CONVAIR

COMMERCIAL CHANGE PROPOSAL

SPEC NO. ZD- 30-013

CUSTOMER Swissair Transport Co., Ltd.

Enclosure: (A) One copy Page 47b - PILOT'S AND COPILOT'S PEDESTAL
(Revised 5-31-61)

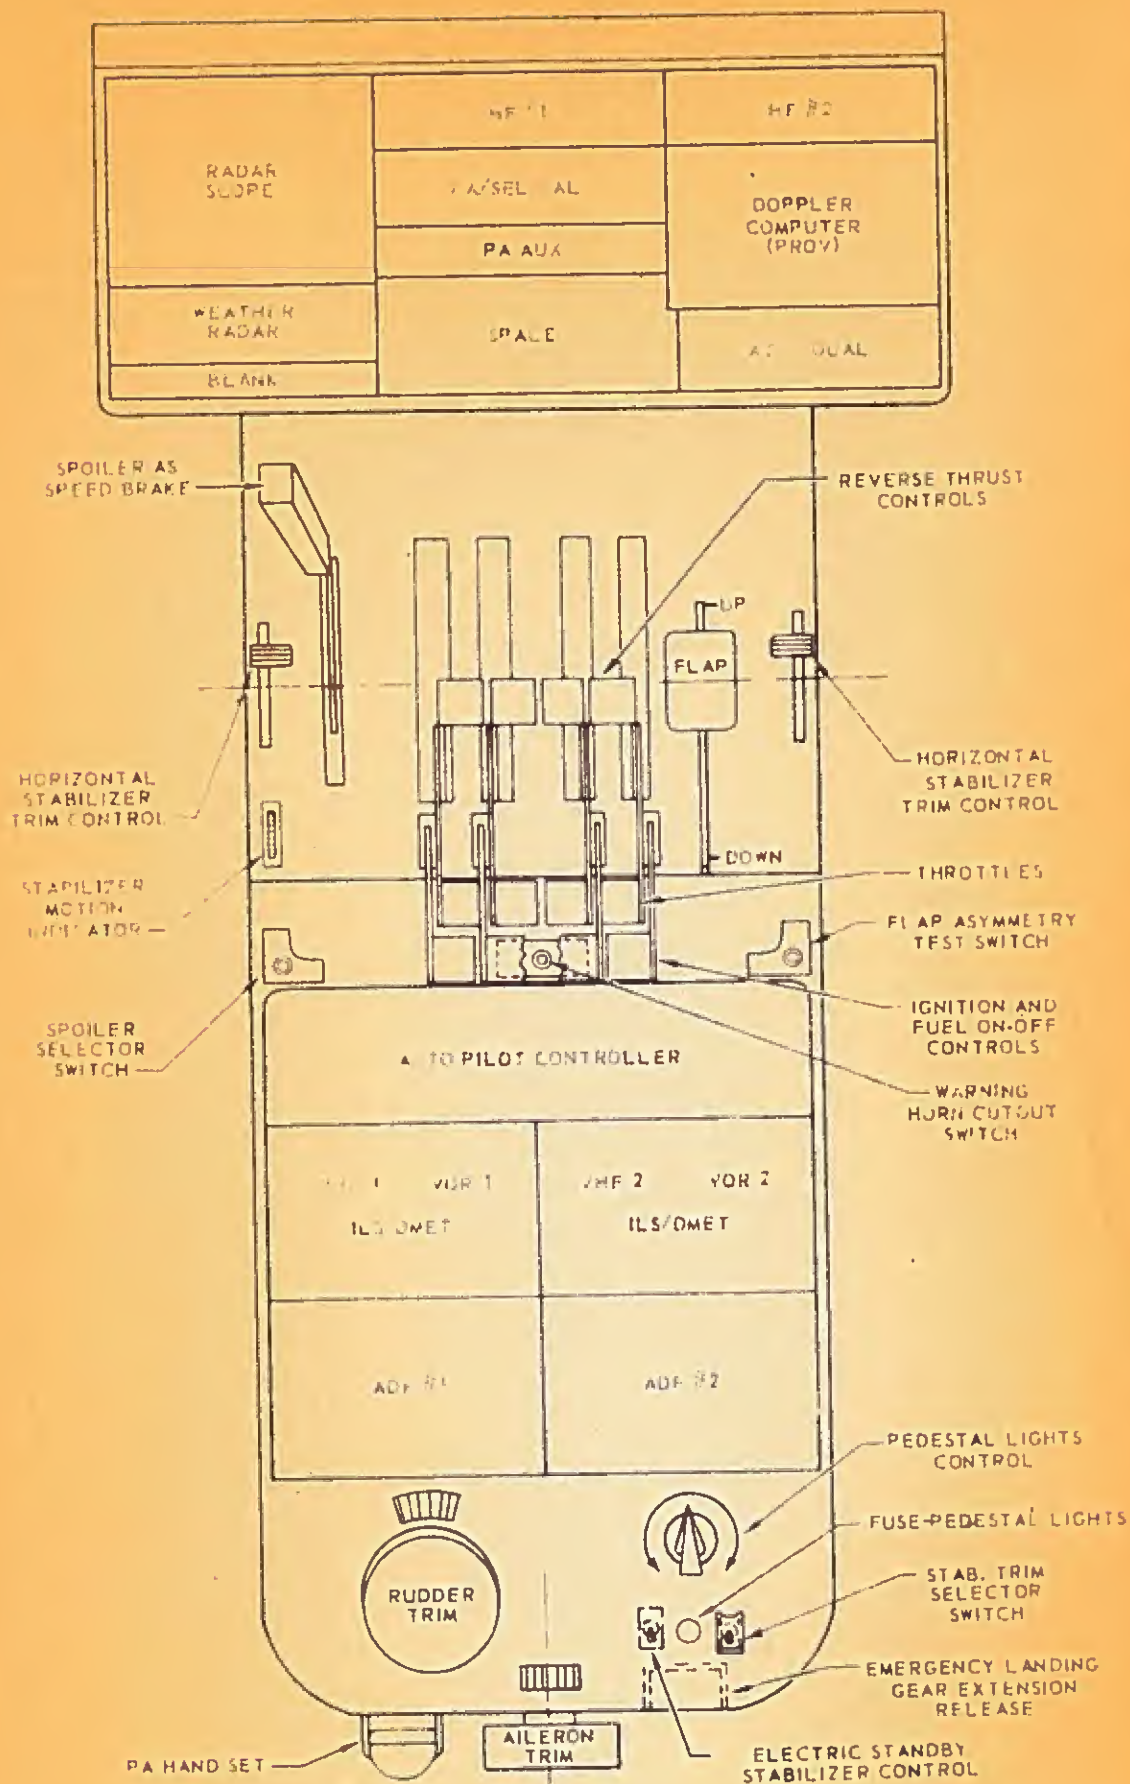
Replace the above illustration in the specification with Enclosure (A) which revises the stabilizer trim control, adds "STABILIZER MOTION INDICATOR", "FLAP ASYMMETRY TEST SWITCH", "FUSE-PEDESTAL LIGHTS", and "WARNING HORN CUTOFF SWITCH", and shows minor nomenclature changes in callouts; and deletes "EMERGENCY MANUAL HORIZONTAL STABILIZER TRIM".

Enclosure: (A) One copy Page 85a - ANTENNA ARRANGEMENT (Revised)

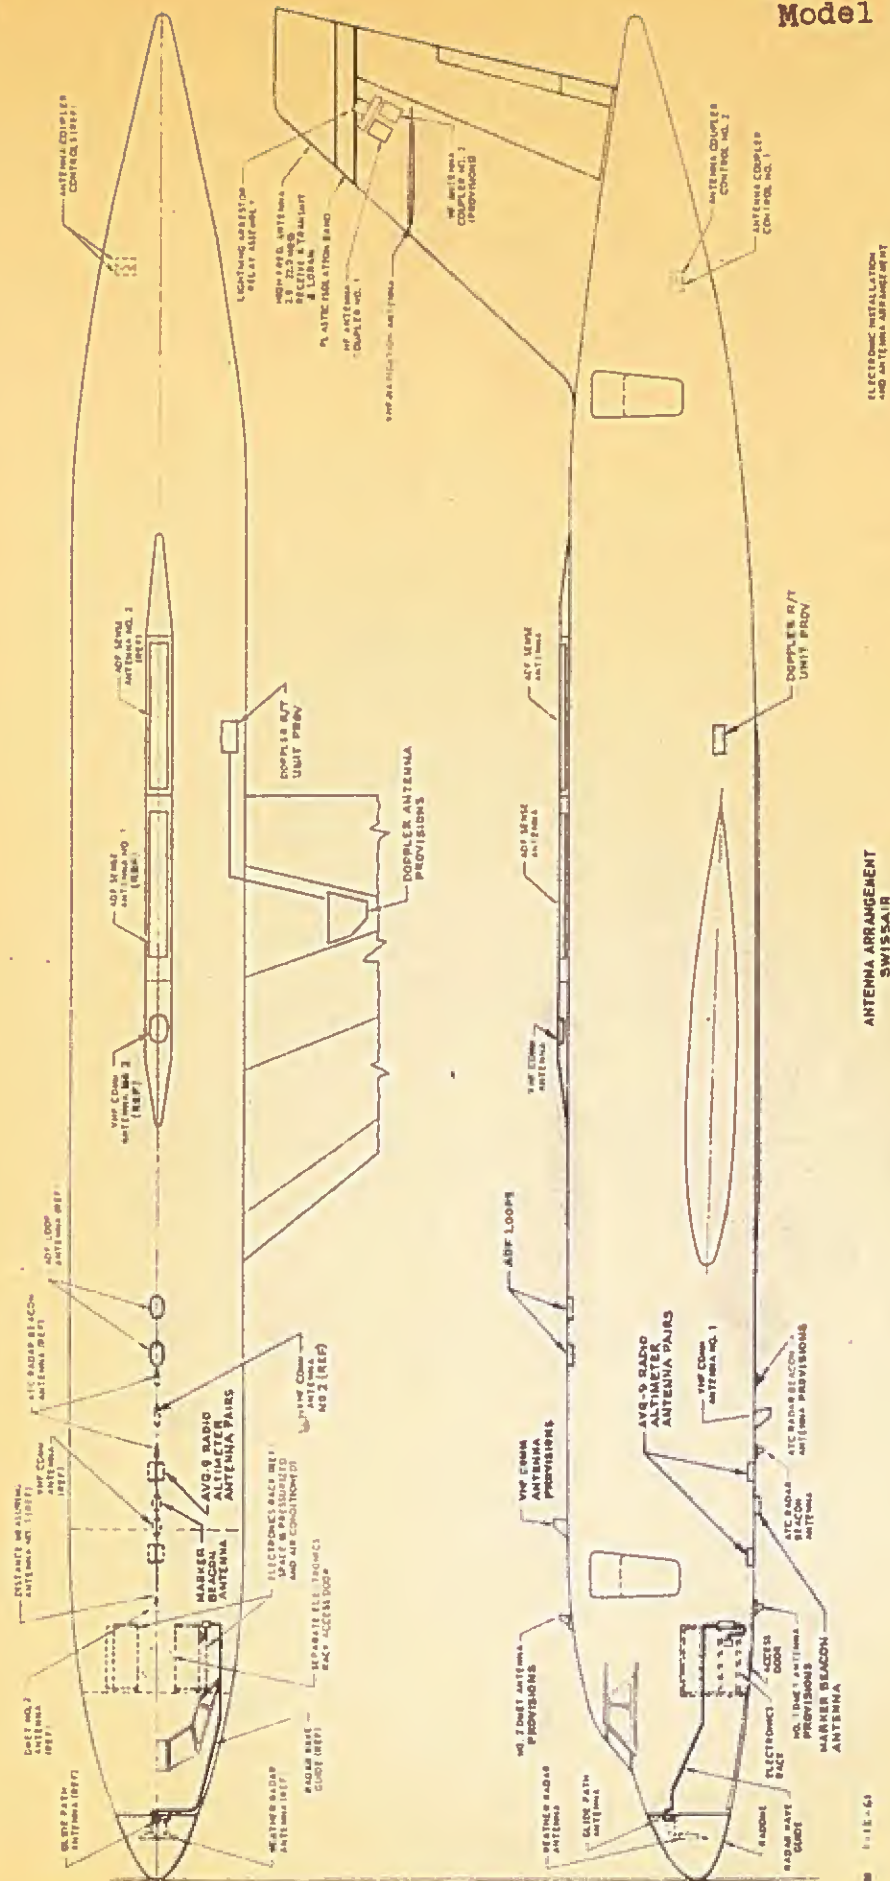
Replace above illustration in the specification with Enclosure (A) which shows the AVQ-9 radio altimeter antennas.

HORIZONTAL STABILIZER
MECHANICAL MOTION INDICATOR

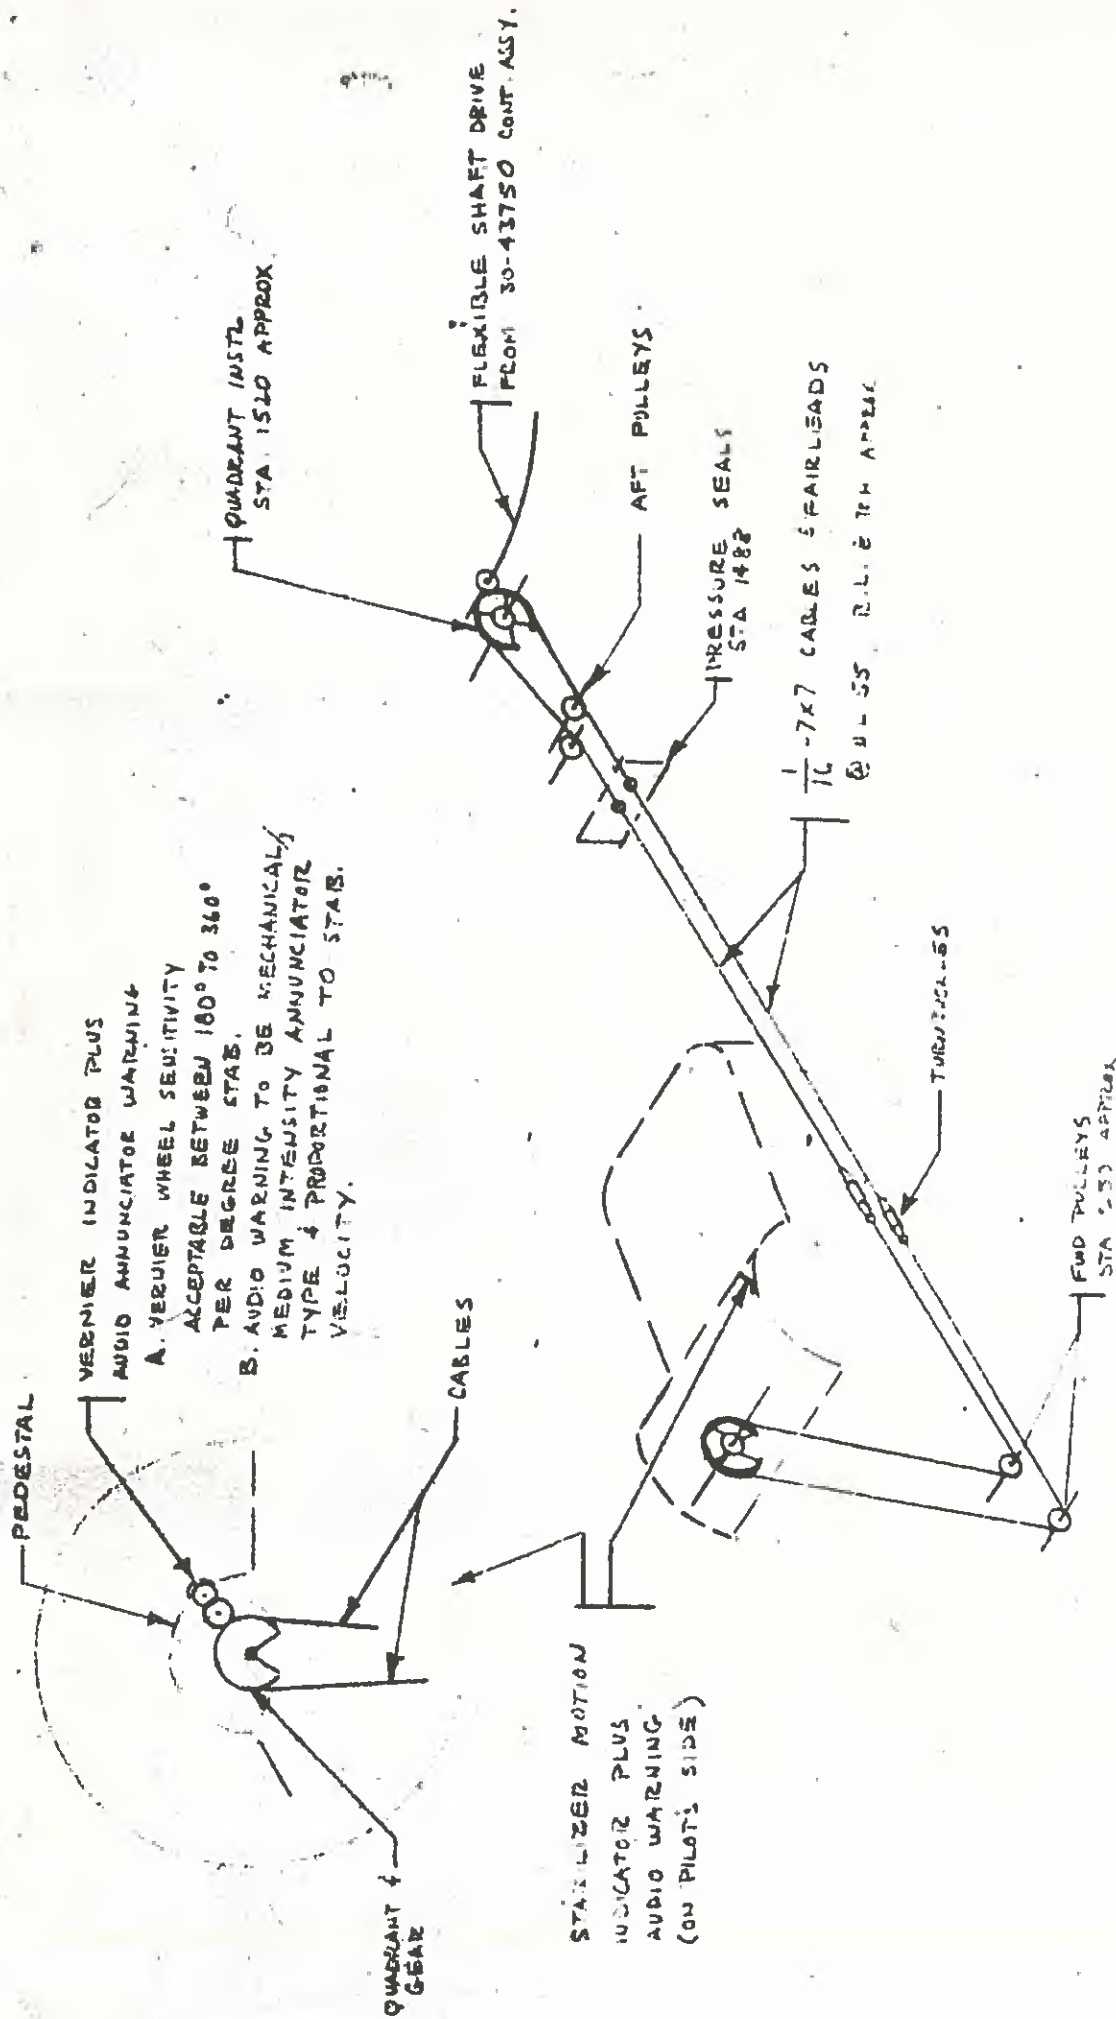
Enclosure: (A) One copy Convair Sketch - HORIZONTAL STABILIZER
MECHANICAL MOTION INDICATOR (For information
only, not part of specification)
